CONSTRUCTION TRAFFIC MANAGEMENT PLAN

Sydney Metro West – Western Tunnelling Package

Westmead Site Operations

Document Reference #: **SMWSTWTP-GLO-WMD-TF-PLN-000002**

Figure 3-2: TGS Hawkesbury between Alexandra Ave and Bailey St Lane 1 closure (refer to Appendix B for full TGS)

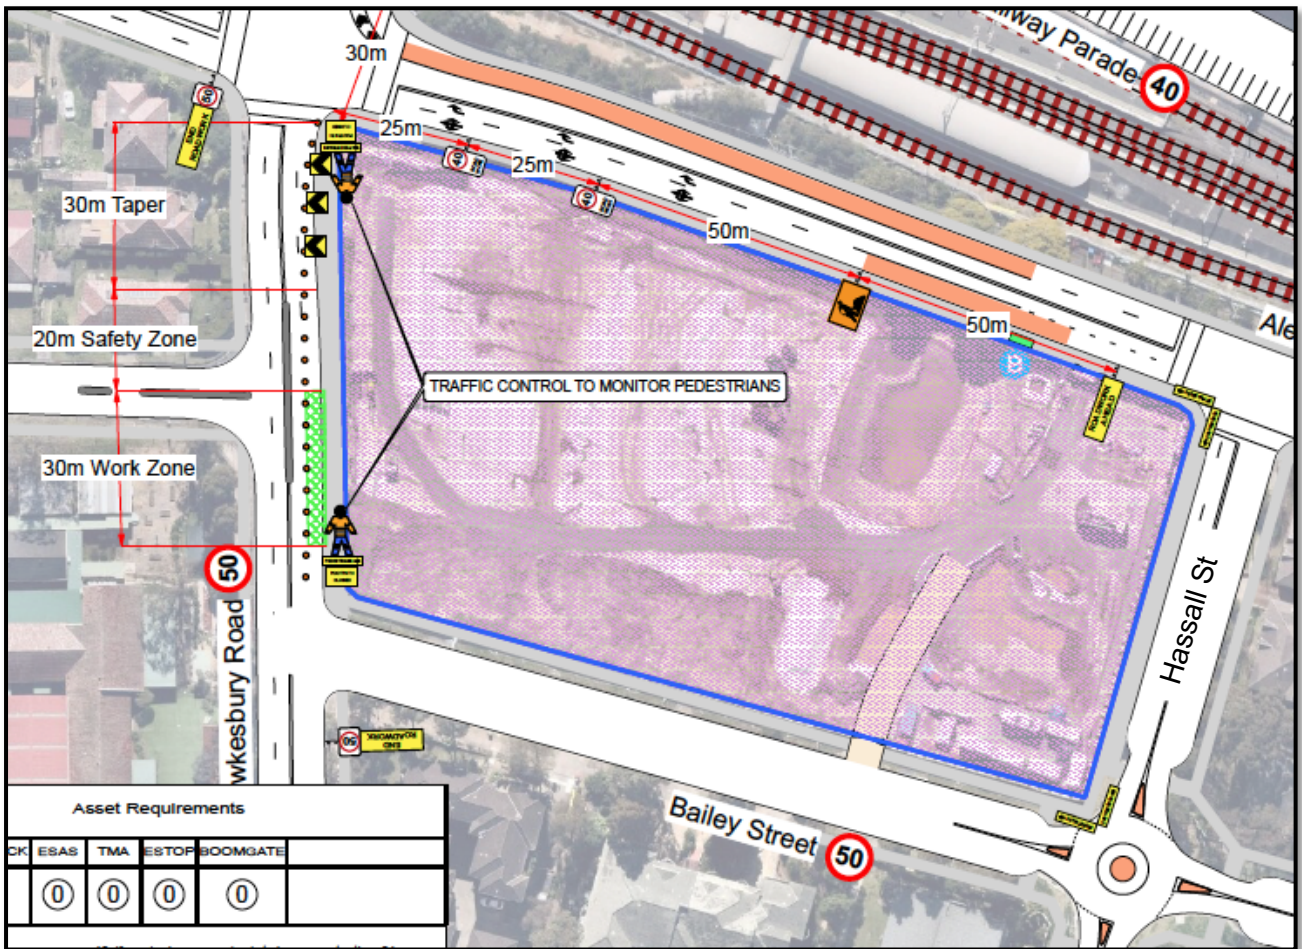
DOCUMENT NO.	TITLE	VER	STATUS	NO.	DATE	COMPANY	RAISED BY	REVIEW DOC. NO.*	DOCUMENT REF*	DEED REF*	COMMENTS / RESPONSE	COMMENT CATEGORY*	CLOSED OUT
				16	24/11/2022	TFN	LWILBY	SMWSTWTP-GLO-WMD-TF-PLN-000002	Figure 3-2	NA	There are footpath closed signs on Hawkesbury Road although the footpath appears to be unobstructed? If this is the case, pedestrians are likely to ignore the signage. Further to this there may be pedestrians heading further south then Bailey Street and the quickest detour for them would be to cross over Hawkesbury Road and then back over at Piddle Street - consideration should be given to more comprehensive wayfinding at this location to assist pedestrians taking the shortest route.	Observation	Y
								SMWSTWTP-GLO-WMD-TF-PLN-000002	Figure 3-2	NA		Observation	Y

16.01	9/01/2023	GLO	BMCNALLY	SMWSTWTP-GLO-WMD-TF-PLN-000002	Figure 3-2	NA	Updated. Traffic Controllers added at each end to direct pedestrians.	Observation	Y
								SMWSTWTP-GLO-WMD-TF-PLN-000002	Figure 3-2	NA		Observation	Y

Figure 3-30: TGS Hassall St and Bailey St roundabout removal stop slow (refer to Appendix B for full TGS and detour route)

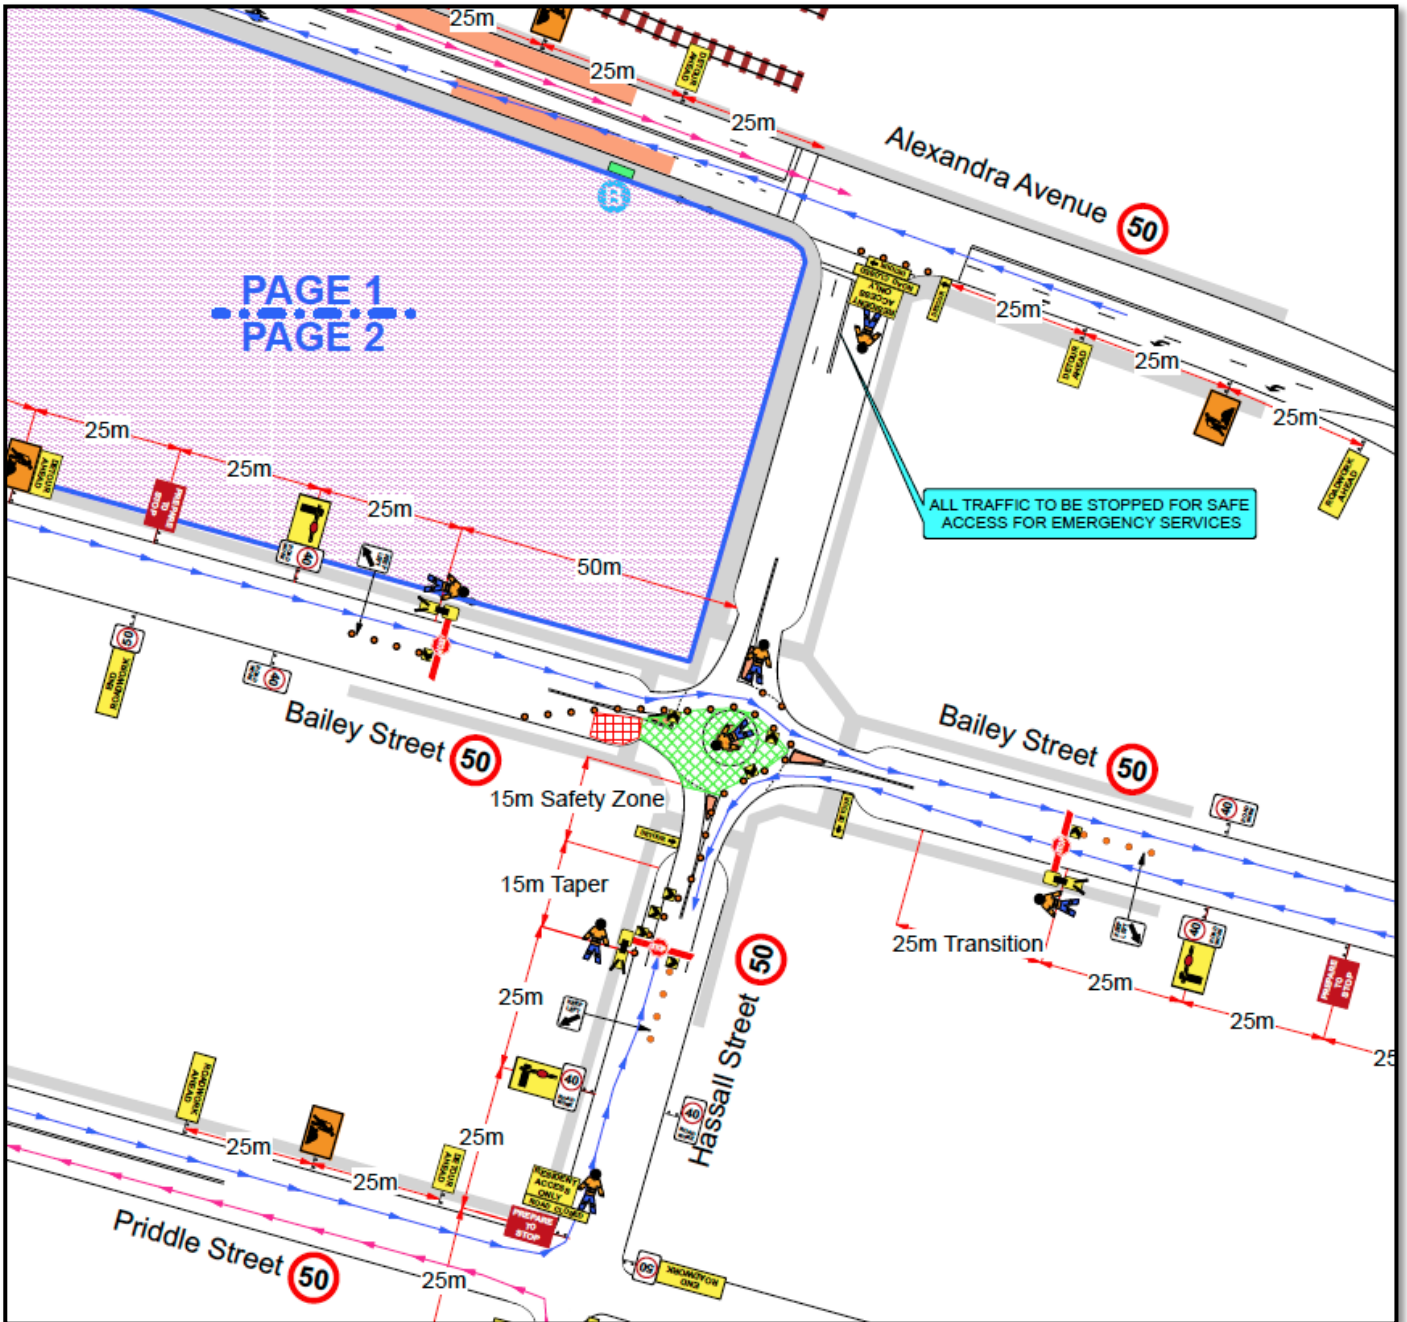
DOCUMENT NO.	TITLE	VER	STATUS	NO.	DATE	COMPANY	RAISED BY	REVIEW DOC. NO.*	DOCUMENT REF*	DEED REF*	COMMENTS / RESPONSE	COMMENT CATEGORY*	CLOSED OUT
								SMWSTWTP-GLO-WMD-TF-PLN-000002	Figure 3-30			Potential Non-Compliance	Y

19.01	9/01/2023	GLO	BMCNALLY	SMWSTWTP-GLO-WMD-TF-PLN-000002	Figure 3-30		Refer to Appendix B. A note has been added under the screen shot. The full TGS details the detour route and VMS messaging	Potential Non-Compliance	Y
								SMWSTWTP-GLO-WMD-TF-PLN-000002	Figure 3-30			Potential Non-Compliance	Y
				20	28/11/2022	SMD	BGORDON	SMWSTWTP-GLO-WMD-TF-PLN-000002	Section 7.3.1		This section states that construction work does not affect emergency access. Figure 3-30 shows a full closure of Hassall St. How will this be managed in regard to emergency services?	Potential Non-Compliance	Y
								SMWSTWTP-GLO-WMD-TF-PLN-000002	Section 7.3.1			Potential Non-Compliance	Y

Figure 3-33: Pedestrian Fencing design Great Western Highway at Pitt St

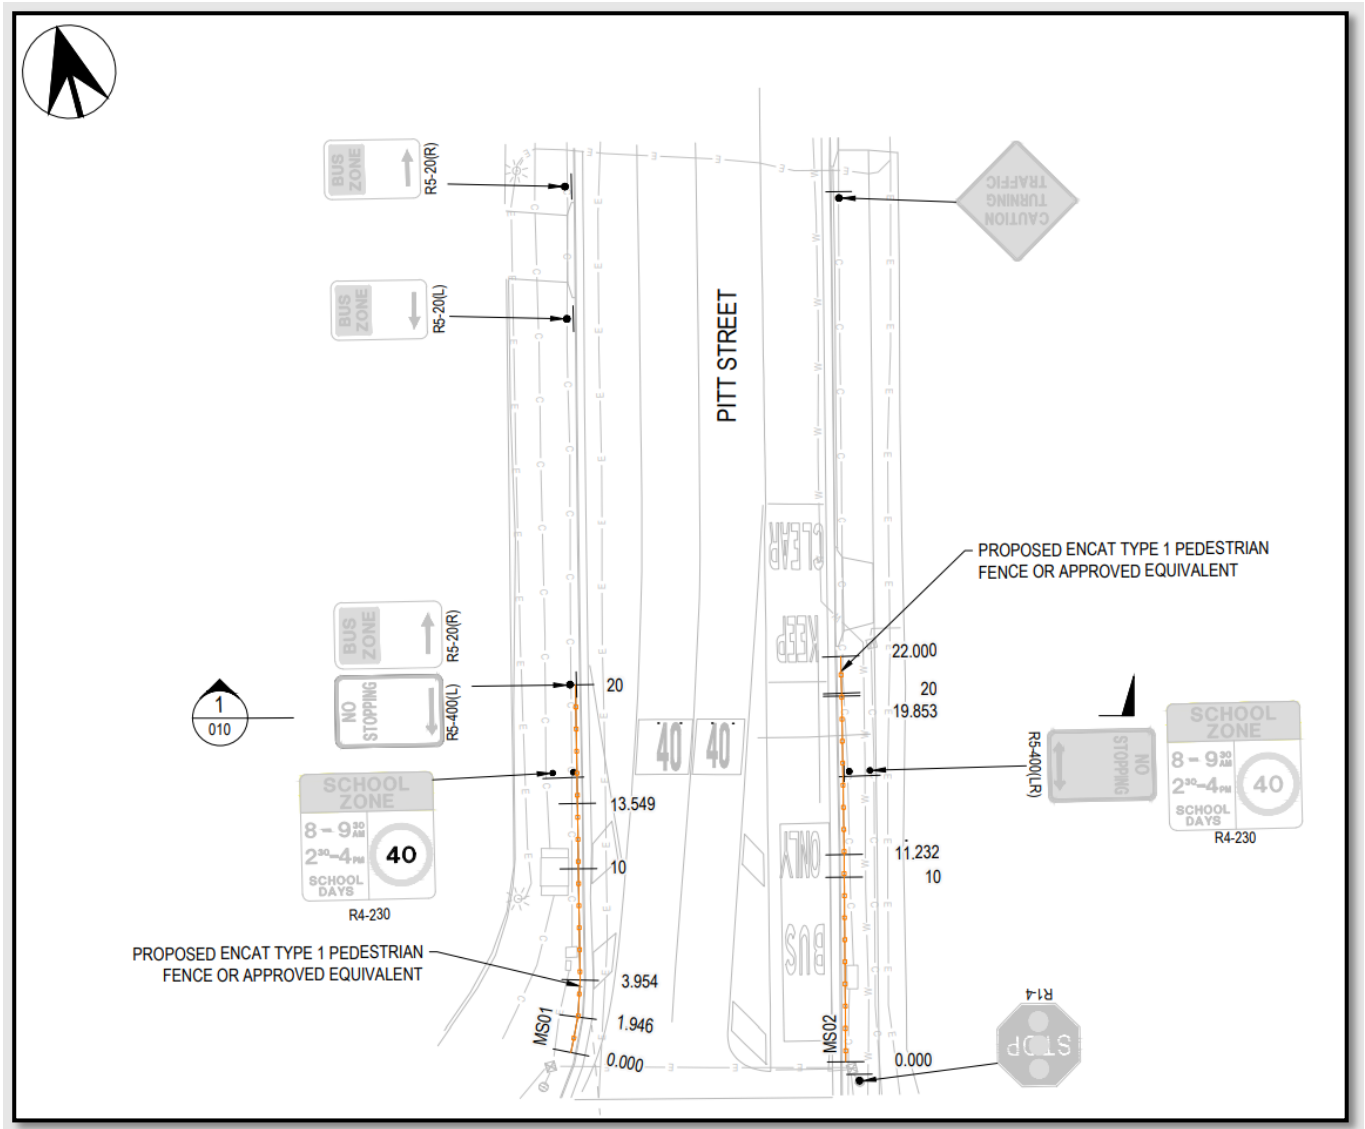
05.01.01	16/01/2023	SCO	VSAHNI				Please provide a copy of the design drawings and RSA included as part of this TMP for reference.	Observation	Y
												Observation	Y
				06	22/11/2022	SCO	PKEYES		Figure 3-33 & Appendix J - Pitt St Fencing		Please confirm that there is a minimum length of 40m for bus zone (articulated buses) with no adjacent fence.	Observation	Y
									Figure 3-33 & Appendix J - Pitt St Fencing			Observation	Y

06.01	9/01/2023	GLO	BMCNALLY		Figure 3-33 & Appendix J - Pitt St Fencing		There is no change to the length of the bus zone and the fence does not continue into the zone.	Observation	Y
									Figure 3-33 & Appendix J - Pitt St Fencing			Observation	Y
				07	24/11/2022	TFN	LWILBY	SMWSTWTP-GLO-WMD-TF-PLN-000002	Figure 3-38 Westmead site entry	NA	Vehicles waiting on the chevron area to turn right into site may obstruct visibility between pedestrians using the refuge and vehicles travelling along Hassall Street. Please confirm if any sight distance checks have been undertaken at this location, and consider any mitigation measures that can reduce the risk of a collision occurring.	Observation	Y
								SMWSTWTP-GLO-WMD-TF-PLN-000002	Figure 3-38 Westmead site entry	NA		Observation	Y

Figure 3-35: TGS Pitt St at Great Western Hwy bus lane SB contraflow (refer to Appendix B for full TGS).

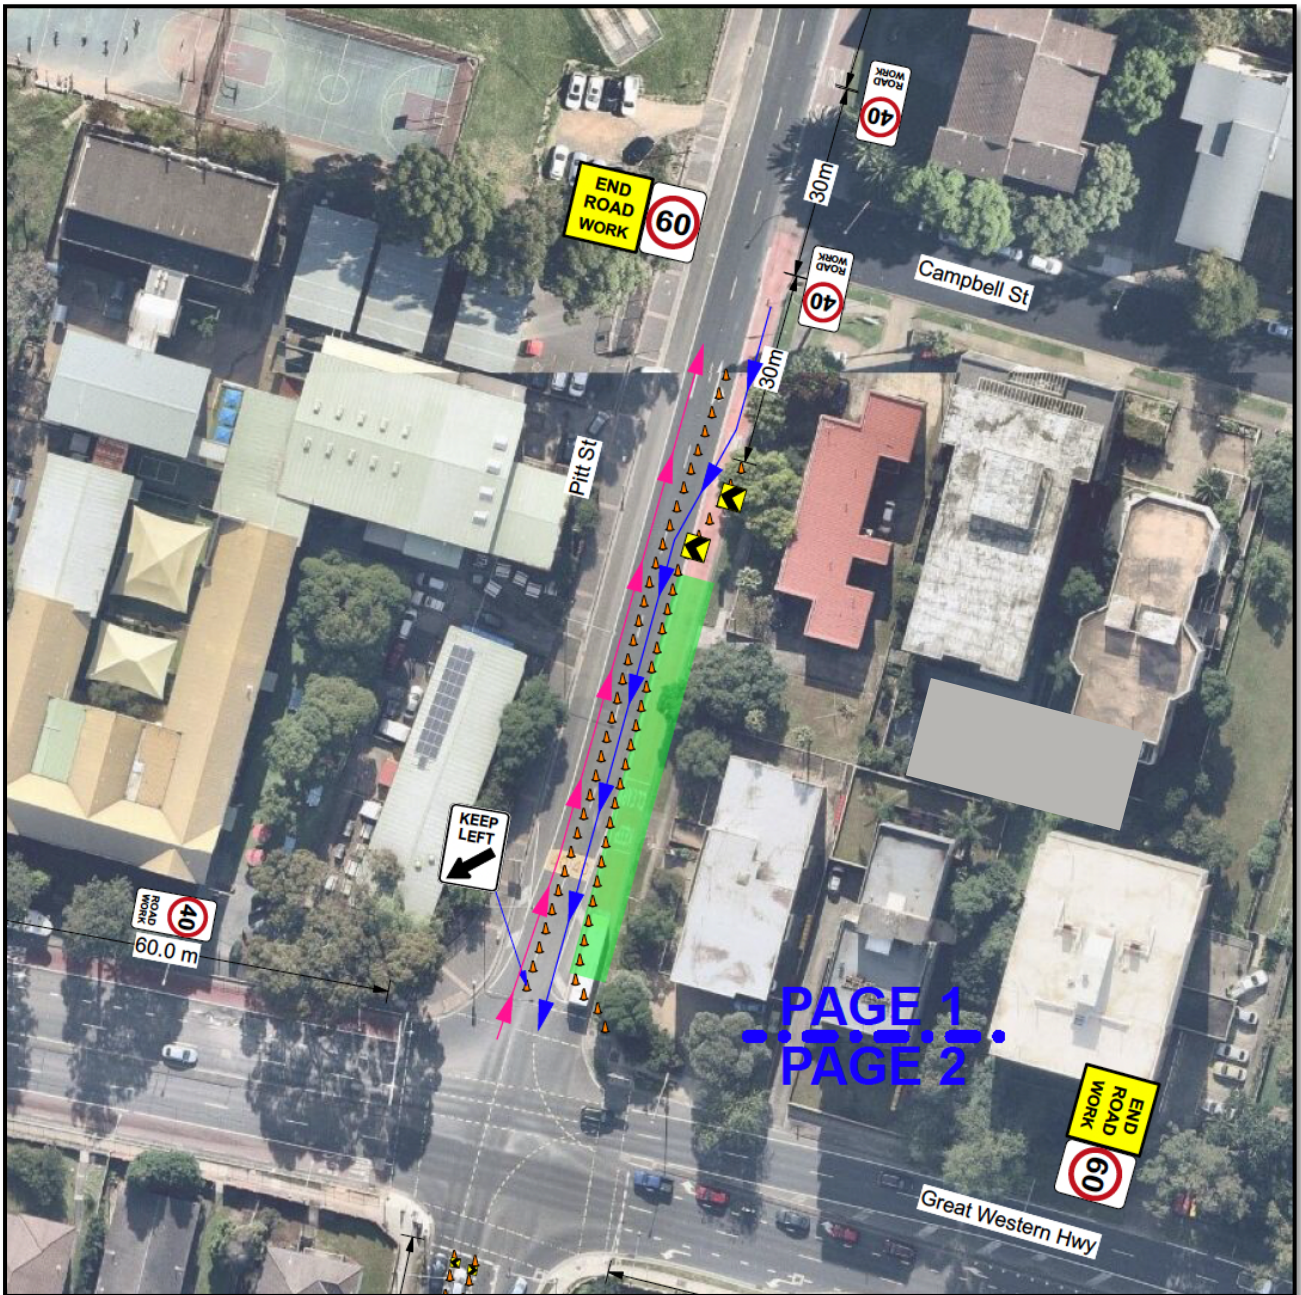
16.01.01	13/01/2023	TFN	LWILBY				The addition of traffic controllers will address the risks raised, thank you. Comment closed.	Observation	Y
												Observation	Y
				17	24/11/2022	TFN	LWILBY	SMWSTWTP-GLO-WMD-TF-PLN-000002	Figure 3-35 TGS Pitt St	NA	The only signage indicating to drivers that the right lane on Pitt Street is under contraflow arrangement appears to be the keep left sign at the last moment. This is likely to result in some drivers turning right from the GWH into the wrong lane, increasing the risk of head on collisions and other unexpected maneuvers. Please consider this risk and demonstrate how it will be managed so far as is reasonably practicable.	Observation	Y
								SMWSTWTP-GLO-WMD-TF-PLN-000002	Figure 3-35 TGS Pitt St	NA		Observation	Y

17.01	9/01/2023	GLO	BMCNALLY	SMWSTWTP-GLO-WMD-TF-PLN-000002	Figure 3-35 TGS Pitt St	NA	The TGS has gone through an RSA and a Quickways traffic control risk assessment with no issues highlighted. Traffic controllers will be onsite to monitor and adjust the TGS if required.	Observation	Y
								SMWSTWTP-GLO-WMD-TF-PLN-000002	Figure 3-35 TGS Pitt St	NA		Observation	Y

Figure 3-43: EIS hourly heavy vehicle movements (source: EIS Chapter 10 page 10-13)

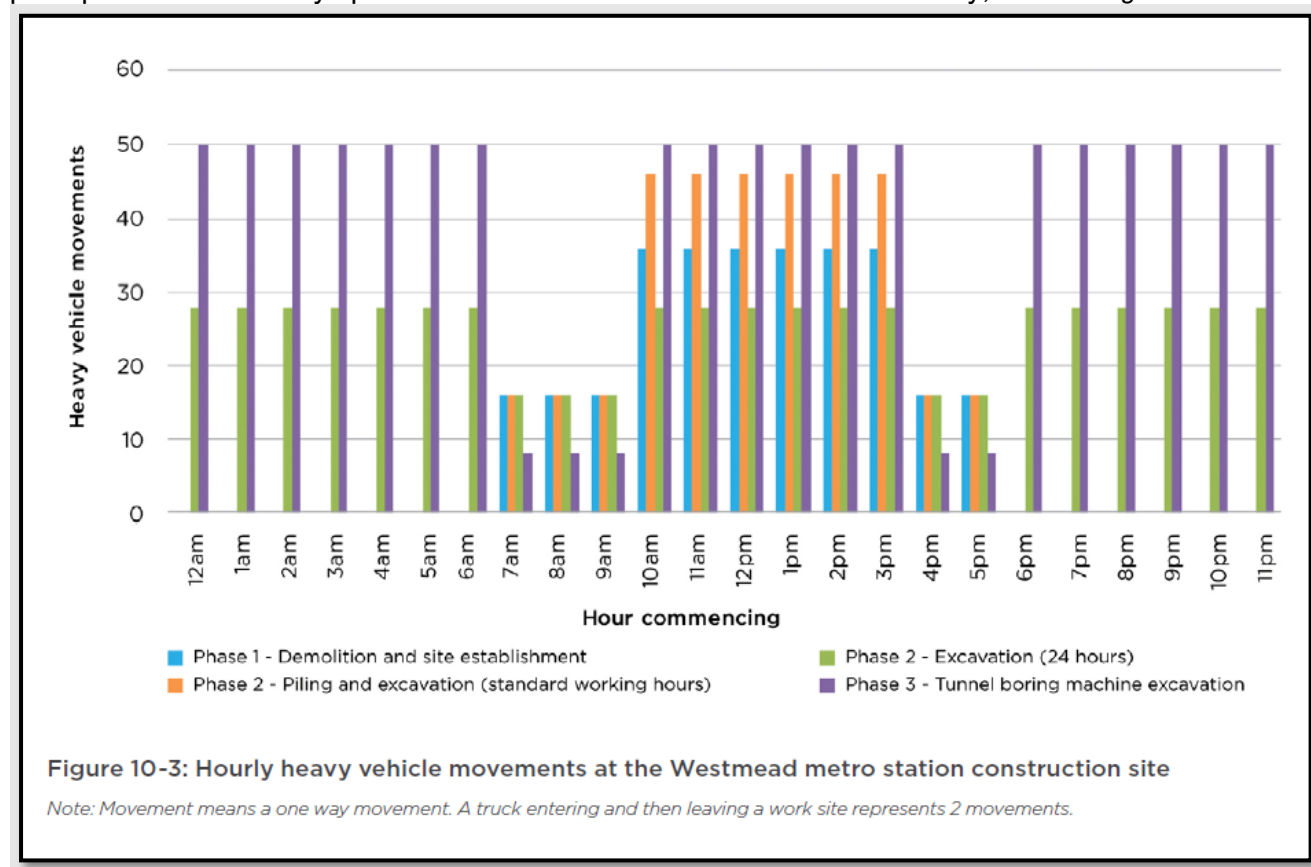
03.01	9/01/2023	GLO	BMCNALLY		General		Section 3.2.1 Updated and TGS added to Appendix B	Observation	Y
									General			Observation	Y
				04	22/11/2022	SCO	PKEYES		Figure 3-43		CJP do not support the changed construction vehicle numbers as proposed. The period 0600-0700 has not been utilised and the period 1800-1900 is underutilised.	Observation	Y
									Figure 3-43			Observation	Y

04.01	9/01/2023	GLO	BMCNALLY		Figure 3-43		Heavy Vehicles numbers have been adjusted to ensure the lower vehicle counts line up with the school bell times. 0600-0700 times for this stage of works are not available for use in the EIS. From 1800-1900 the numbers have been adjusted so they line up with the EIS and the numbers between 1600-1700 have been reduced.	Observation	Y
									Figure 3-43			Observation	Y
				05	22/11/2022	SCO	PKEYES		Appendix E		Please confirm that the Road Safety Audit was undertaken on the long term setup and not the just the TGS..	Observation	Y
									Appendix E			Observation	Y
